September 30, 2019

**Subject: ITB #1598-B: SFWTP Chlorine Dioxide Generation System - Addendum #1**

GRADING AND DRAINAGE PLAN	
LAND LOT - SEC. 18A, 201 & 202 DESEAN	SCALE 1" = 100'
DISTRICT - 48	DRAWN - DSC
SECTION -	CHECKED - DRU
CITY -	DATE - 10/16/06
COUNTY - FAYETTE	FILE NO. -
BY - JMM	APPROVED - JMM
STATE - MISSOURI	SHEET NO. - 9

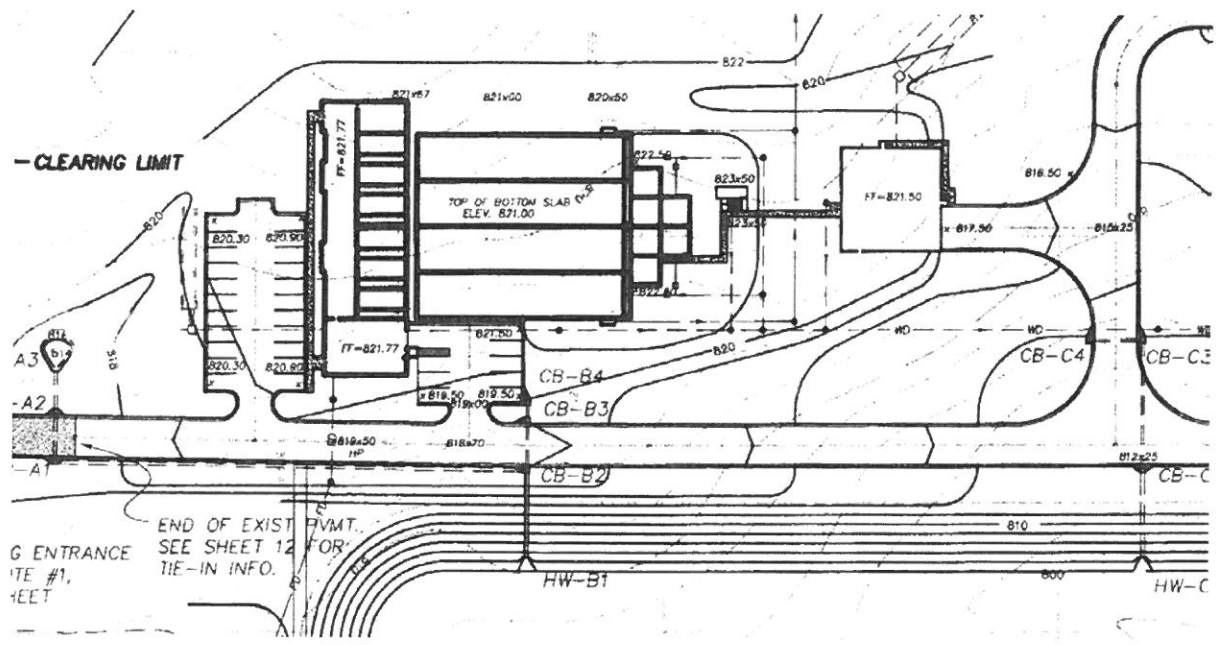
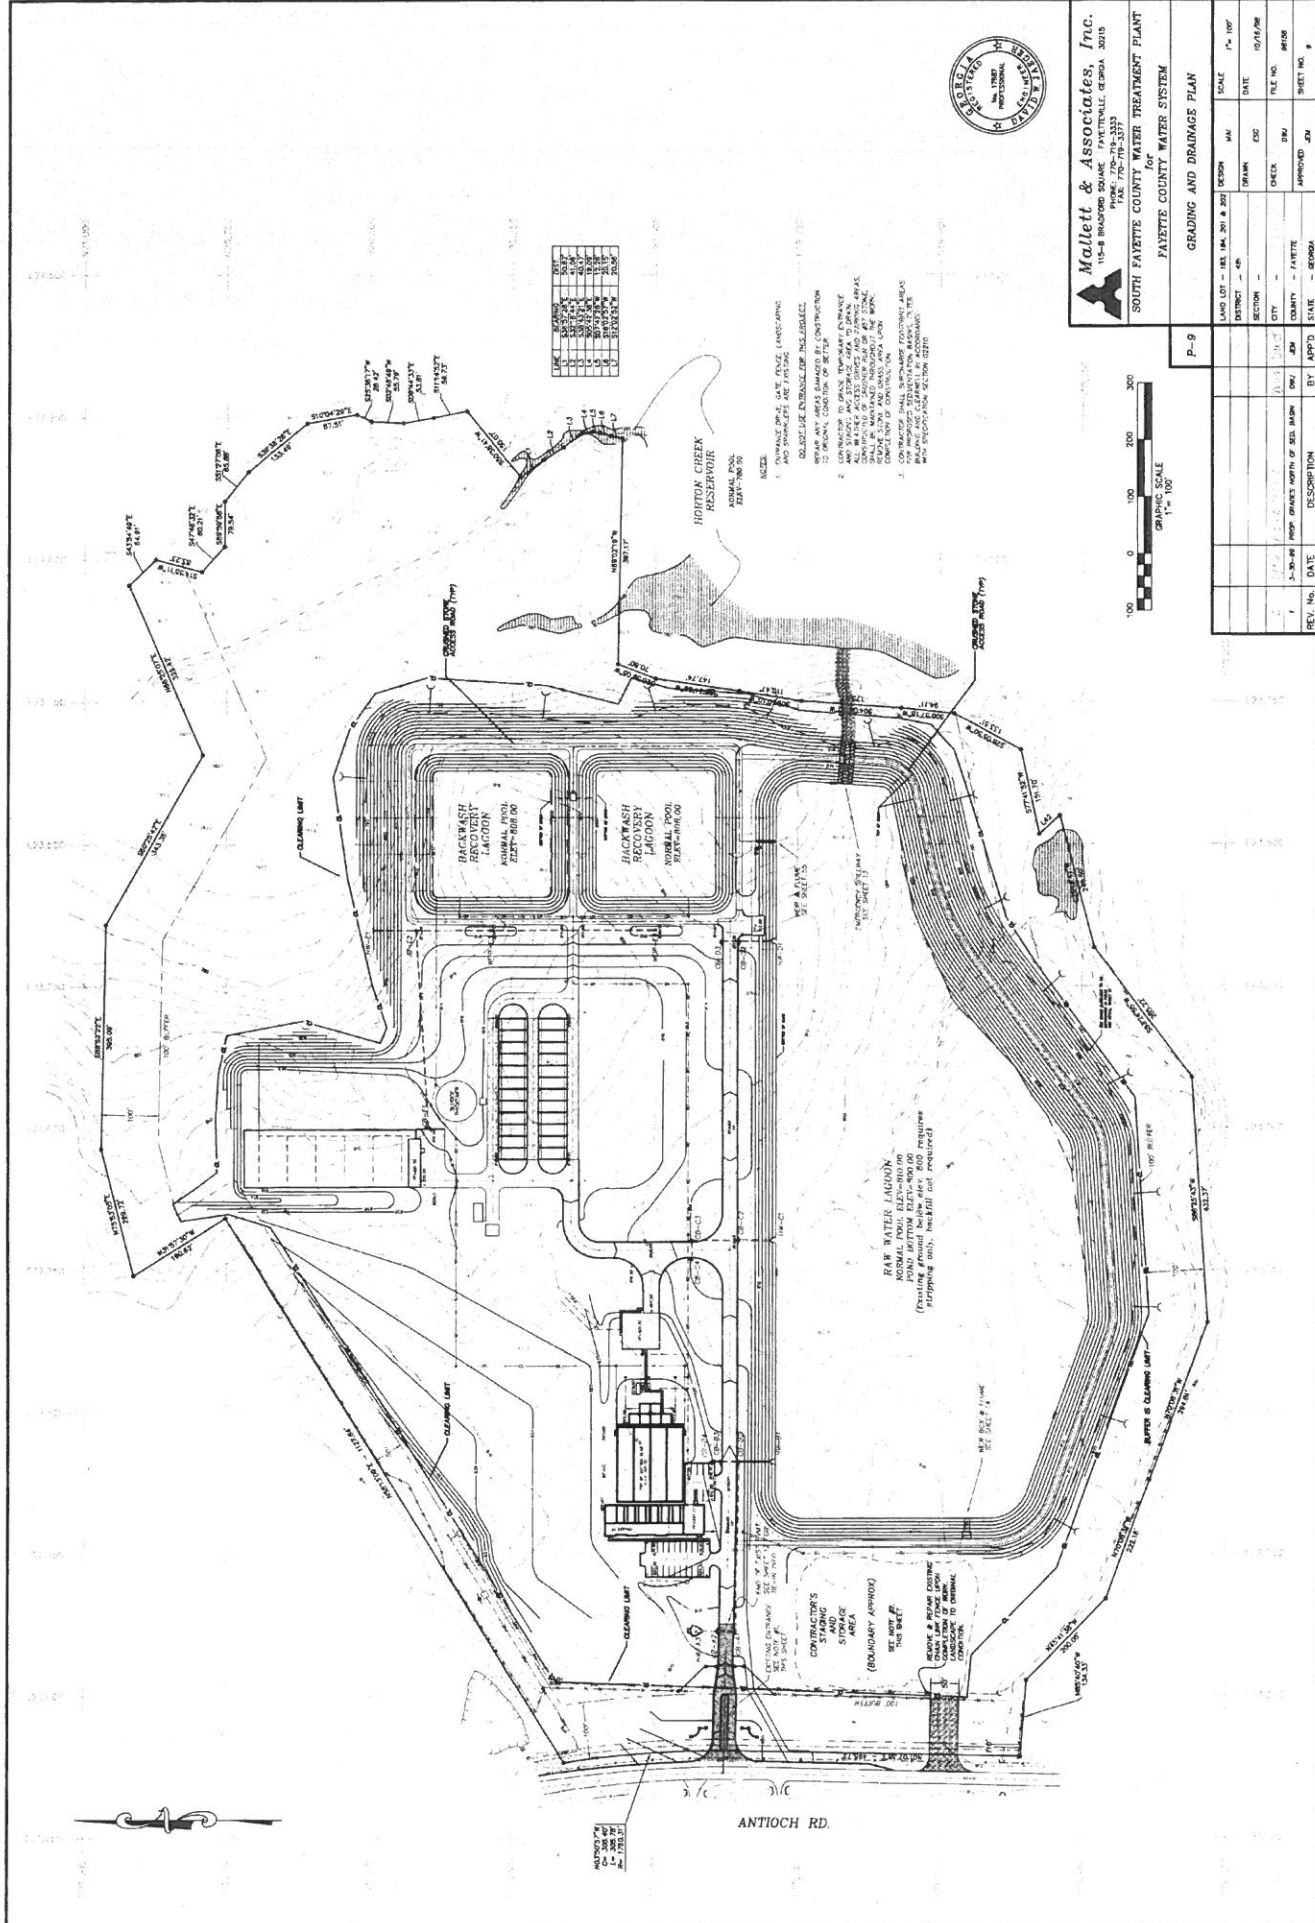
**4. Do the civil drawings show grading around the containment structure?**

For the grading of the site, the civil drawing only indicates the slope and FFE's of the structure for elevation reference. Existing contours provided by the original design drawings (see attached .pdf for the 2 ft contours of the site); because of the size of the project, a survey was not required/requested.

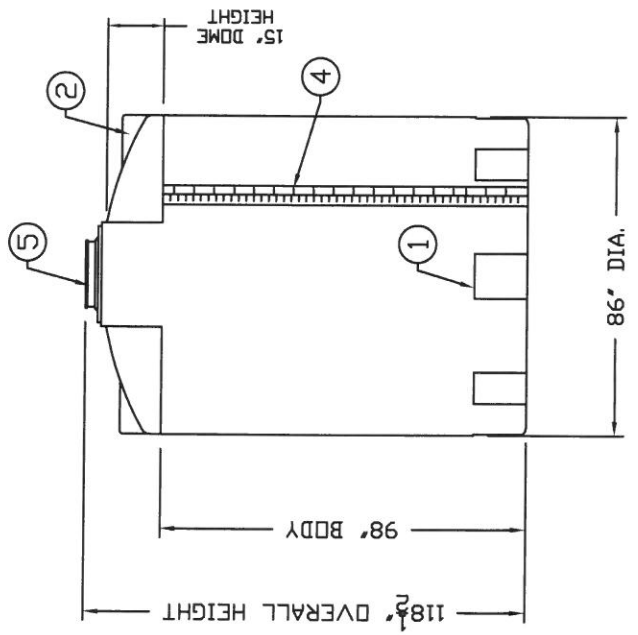
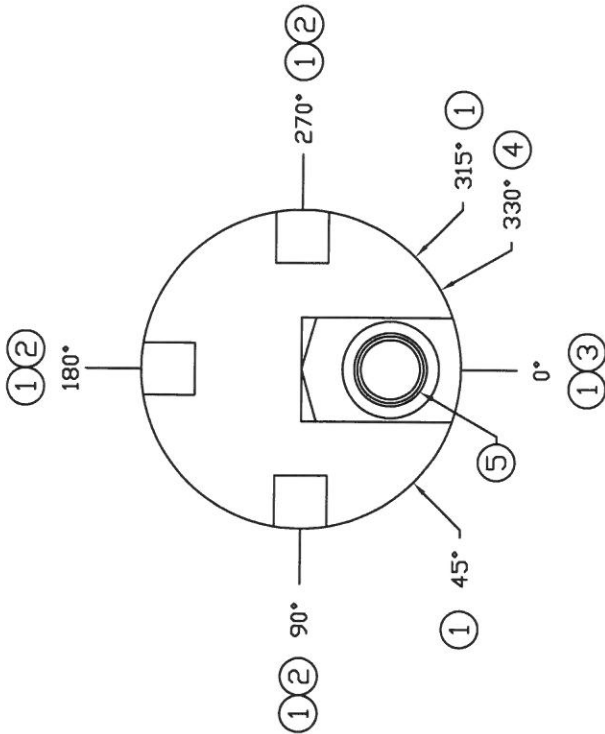
**10. The polypropylene sulfuric acid tank has only Polyprocessing as a named manufacturer; we would like to have Assmann-USA named as an equal utilizing their Full Drain Outlet (FDO) equipped 2500 gallon tank (see attached drawing). Please advise. (Attachment)**

We are not adding additional named suppliers to the equipment specs during bid phase. In the ITB please refer to Standard General Conditions of the Construction Contract, Article 7 – Contractor's Responsibilities, 7.04 "Or Equals" and Instructions to Bidders, 00 21 -13 – 5, #10 Substitute and "Or-Equal" Items.
